Submissions Report

Major civil construction work
between The Bays and Sydney CBD

Sydney Metro West

Submissions Report – **Major civil construction work between The Bays and Sydney CBD**

Figure 2-1: Modified boundary at The Bays tunnel launch and support site

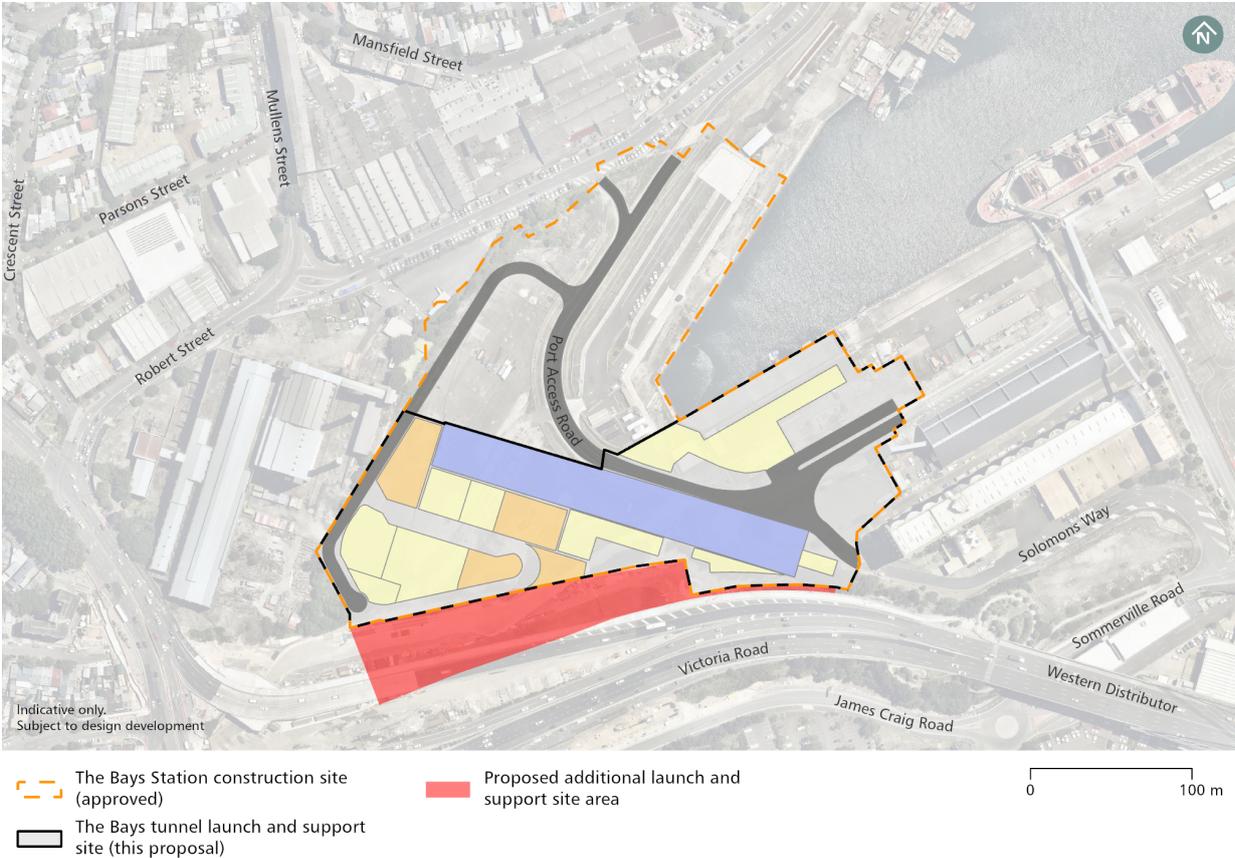
Figure 5-8 of the Environmental Impact Statement incorrectly shows the spoil storage footprint overlapping a Cement Australia heavy vehicle parking area. This parking area would not be used to store spoil for this proposal.

Since the exhibition of the Environmental Impact Statement, it was proposed that Sydney Metro use a portion of the WestConnex Rozelle Interchange construction site upon completion of WestConnex Rozelle Interchange. This parcel of land would then continue to form part of future stages of Sydney Metro West following the completion of this proposal. This parcel of land would primarily be used for laydown, in addition to other surface construction activities.

Figure 5-8 of the Environmental Impact Statement has since been updated to reflect these changes and is shown below in Figure 2-1.

Figure 2-2 Pymont Station construction sites haul route as described in the Environmental Impact Statement

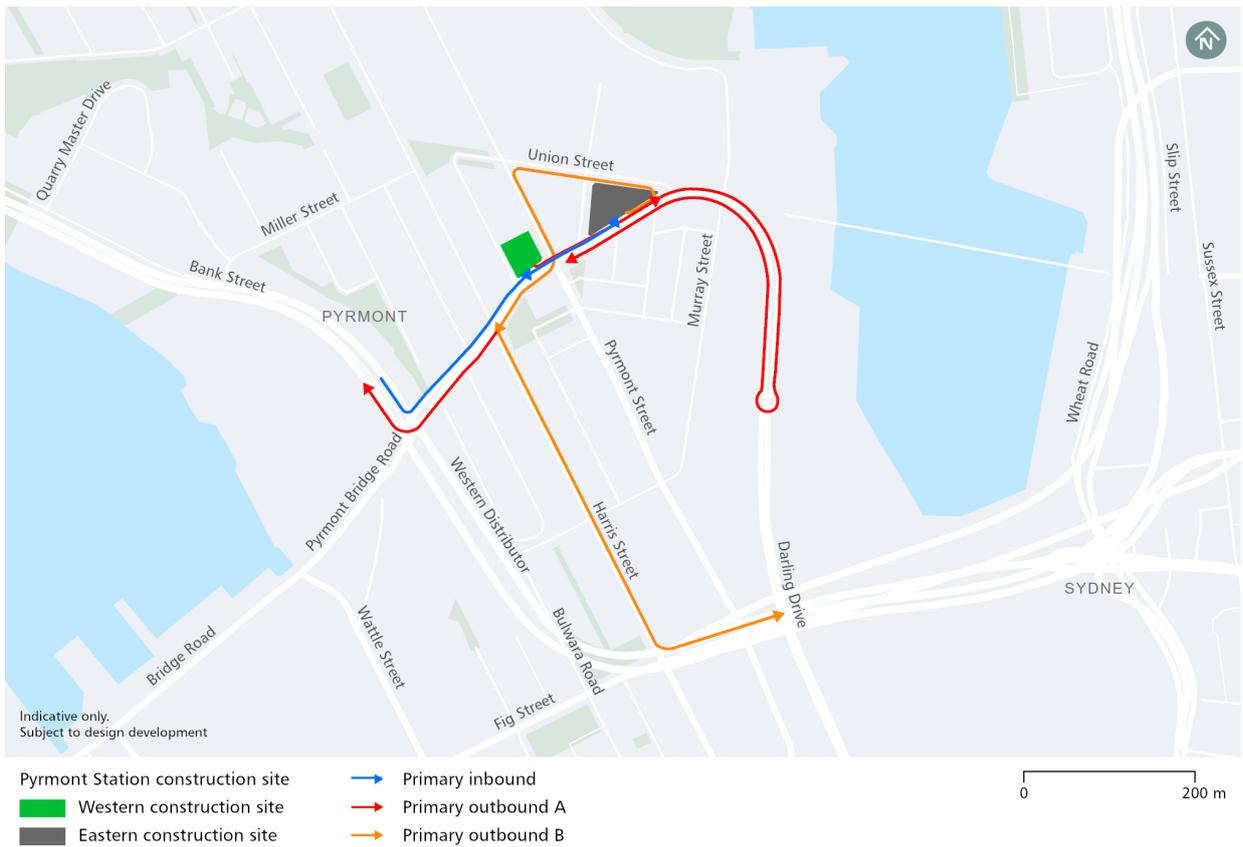
Figure 2-2 shows the proposed primary haul routes for Pymont Station construction sites as described in the Environmental Impact Statement. Following consultation with Transport for NSW, a revised outbound haul route has been adopted for these construction sites to improve traffic outcomes. The revised haul route is shown in Figure 2-3, and would involve:

- A revised outbound route southbound along Pymont Street then onto the Western Distributor. This would avoid the use of Harris Street and avoid direct impacts to the intersection of Harris Street and Fig Street
- A revised inbound route for the eastern site by turning left from Pymont Bridge Road onto Edward Street and right onto Union Street
- A revised outbound route from Union Street egress, left onto Pymont Bridge Road, returning via the Darling Drive roundabout and Pymont Street
- Retention of the westbound outbound route back onto the Western Distributor/Anzac bridge.

Figure 2-3 Revised haul route at Pymont Station construction sites

Figure 2-4 Modelled intersection performance at the Pyrmont Station construction sites

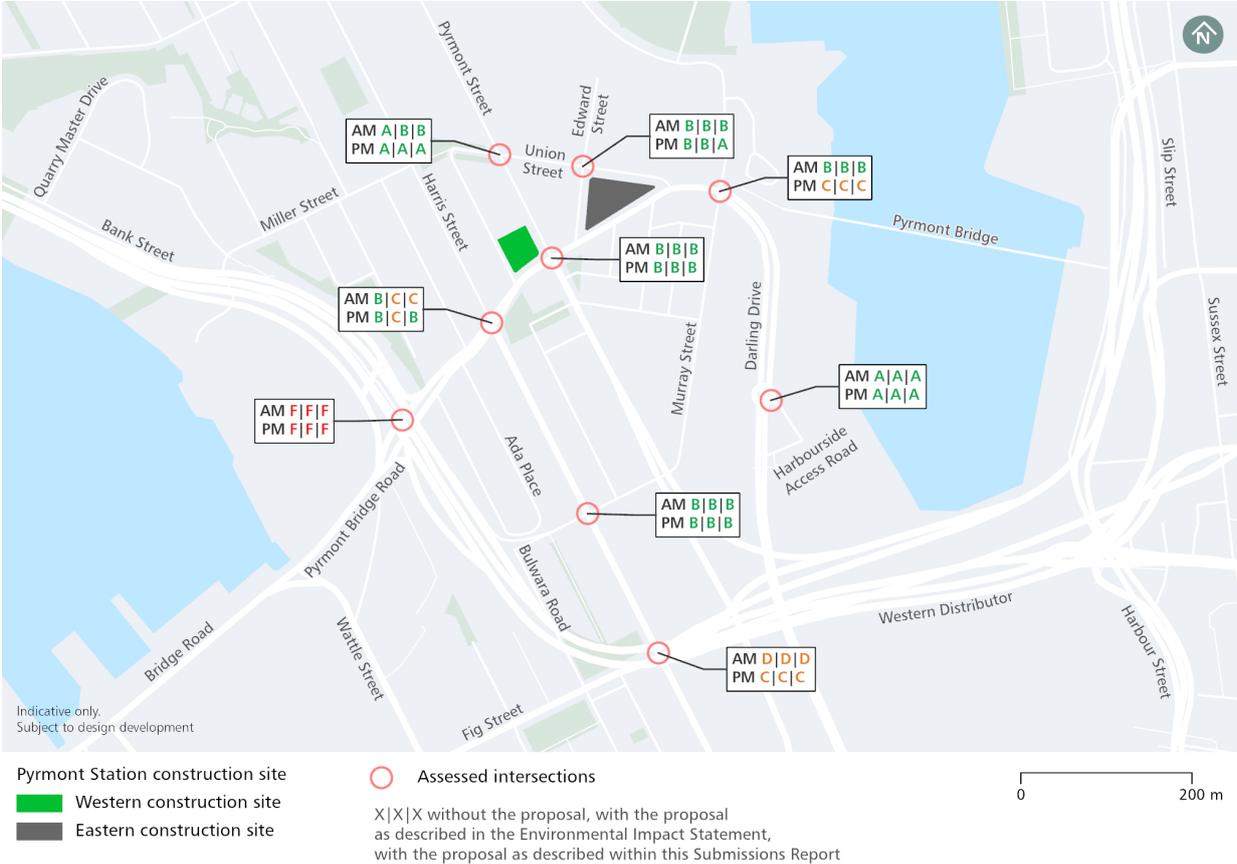
Modelled intersection performance which considers the revised haul routes and additional construction heavy vehicles is shown in Figure 2-4. Updated modelling results for all intersections are provided in Appendix B of this Submissions Report.

- Pyrmont Bridge Road/Harris Street during the evening peak – From Level of Service C to B, with a reduction in average delay of 13 seconds per vehicle compared to the assessment provided in the Environmental Impact Statement
- Union Street/Edward Street during the evening peak – From Level of Service B to A, with a reduction in average delay of four seconds per vehicle compared to the assessment provided in the Environmental Impact Statement. This intersection would operate at the same level of service with or without this proposal in 2024.

These results show that the proposed construction traffic volumes and haul routes are likely to result in some change to overall Level of Service on the surrounding road network, with improved outcomes (due to the haul route changes) at some intersections.

Figure 2-6 Revised haul route at Hunter Street Station construction sites

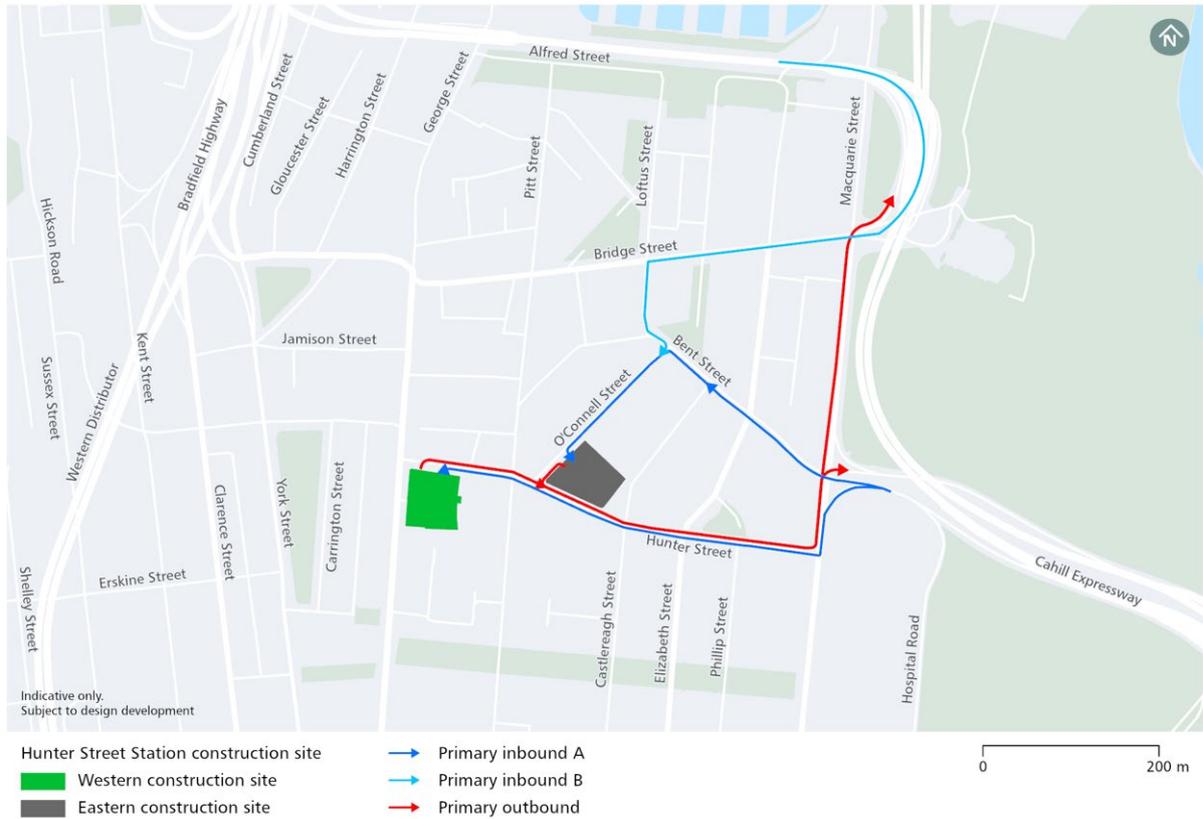
Figure 2-5 shows the proposed haul routes for Hunter Street Station (Sydney CBD) as described in the Environmental Impact Statement. Following consultation with Transport for NSW and City of Sydney, a revised inbound haul route has been adopted for The Hunter Street Station (Sydney CBD) western construction site to improve traffic outcomes. The revised haul route is shown in Figure 2-6 and would involve construction traffic travelling to the western construction site via Macquarie Street and Hunter Street.

Figure 2-7 Modelled intersection performance at the Hunter Street Station construction sites (preferred route)

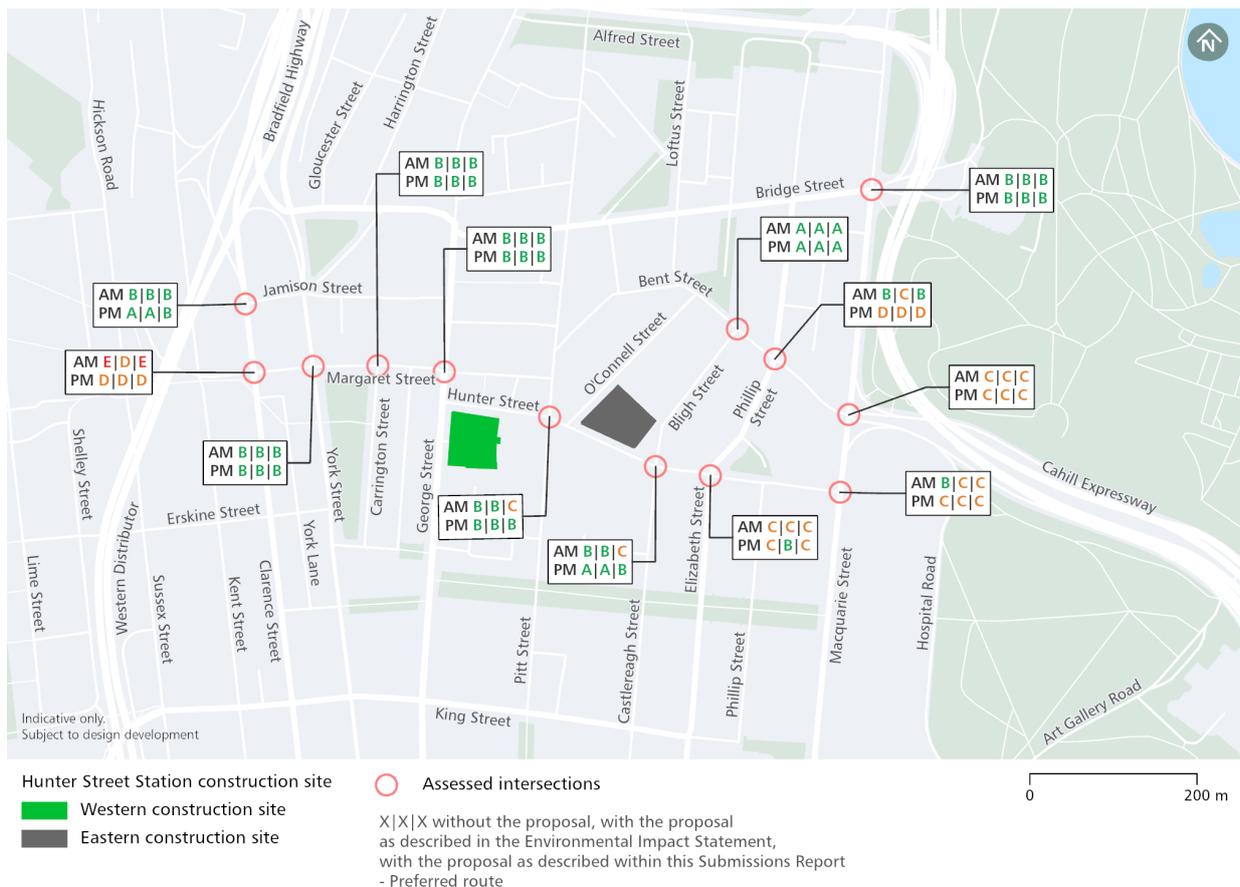
Modelled intersection performance which considers the revised haul routes and additional construction heavy vehicles is shown in Figure 2-7. Updated modelling results for all intersections are provided in Appendix B of this Submissions Report.

- Margaret Street/Clarence Street in the morning peak hour – While this intersection is not part of the proposed haul route, modelling indicates a change from Level of Service D to Level of Service E, with a forecast increase in average delay of about four seconds per vehicle compared to the assessment provided in the Environmental Impact Statement
- Clarence Street/Jamison Street in the evening peak hour – While this intersection is not part of the proposed haul route, modelling indicates a change from Level of Service A to B, with a forecast increase in average delay of about one second per vehicle compared to the assessment provided in the Environmental Impact Statement.

Transport for NSW will lead investigations into the following potential road network changes near the Hunter Street (Sydney CBD) western construction site in collaboration with Sydney Metro and the City of Sydney:

- Partial or full closure of Hunter Street to through traffic to/from George Street and Margaret Street
- Options to reallocate road space on the western part of Hunter Street.
